Planning Application 21/2758/FUL

With reference to Document 'Design Access Statement MOL Slide' (3446994.pdf)

Proposed Open Space

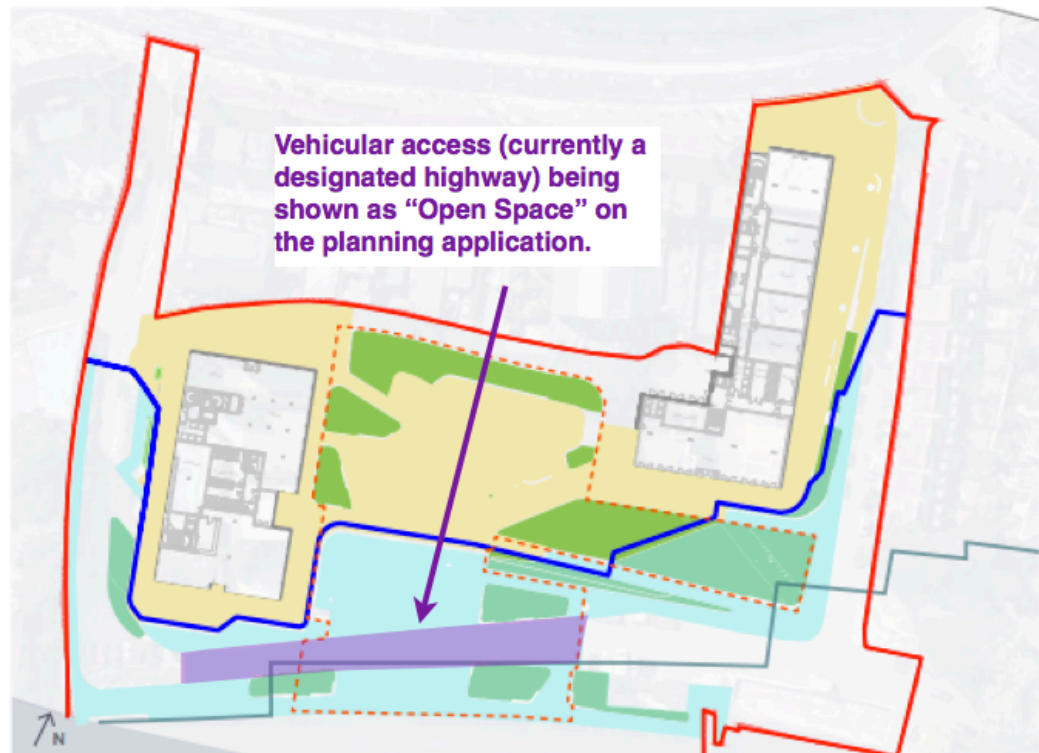
There remain inconsistencies between how the 'Existing Open Space' and the 'Proposed Open Space' are being represented. The same definition of Open Space would not appear to be being applied. See Areas 7 and 8 on the graphic below. It is noted that the definition of Open Space has been taken from both the Planning Policy Framework and the London Plan and **"adapted slightly to fit the context of the this site."** These 'adaptations' should be equally applied to both the Existing and Proposed.

Additional inaccuracies on the "Existing Open Space" graphic (see numbering on graphic):

1. The artificially grassed areas of the Diamond Jubilee Gardens are shown as Hardscape rather than Softscape.
2. The planting beds on either side of the central hedges are shown as Hardscape rather than Softscape.
3. An area of raised Softscape of the Embankment-level Jubilee Gardens has been omitted.
4. The raised seating area at the bottom of Water Lane - a combination of Hardscape and Softscape - has been omitted.
5. A substantial section of the hedges (Softscape) around the enclosed Playground is shown as Hardscape
6. The area around the Eel Pie Island Bridge is inconsistently represented.

On the same slide, the 'Proposed Open Space' is shown to include the area on the Embankment to which there will be vehicular access.

This is currently a designated highway, and any closure of this highway will require a Stopping-up Order. In the absence of a Stopping-up Order, it is unclear as to whether this should be represented as 'Proposed Open Space' for the purposes of this planning application.
